## CONCLUSIONS AND SUGGESTIONS AFTER EEP-VCF STAFF VISIT AT THE AMNÉVILLE ZOO

Following the proposal from Amnéville zoo to participate in the Bearded Vulture EEP network, it was accorded between Amnéville zoo and EEP/VCF to invite Alex Llopis to visit the Zoo, and have a look for the possibilities to house a pair of Bearded Vultures in their facilities.

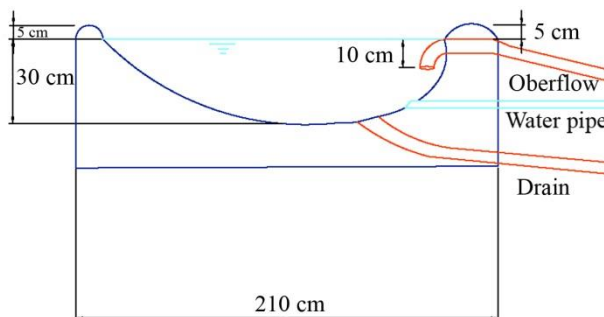
For preventing collisions by flying against the fence is recommended **to install perches around the aviary** (60cm away from the mesh and **never higher than the nest**). This gives them the possibility to move around the cage without getting on the ground, especially when the nest must be controlled by the keepers. Furthermore by installing perches throughout the aviary, pairing birds can move towards each other gradually. Subordinate birds can escape from attacks by the other and can choose to sit on a perch where they feel safer.
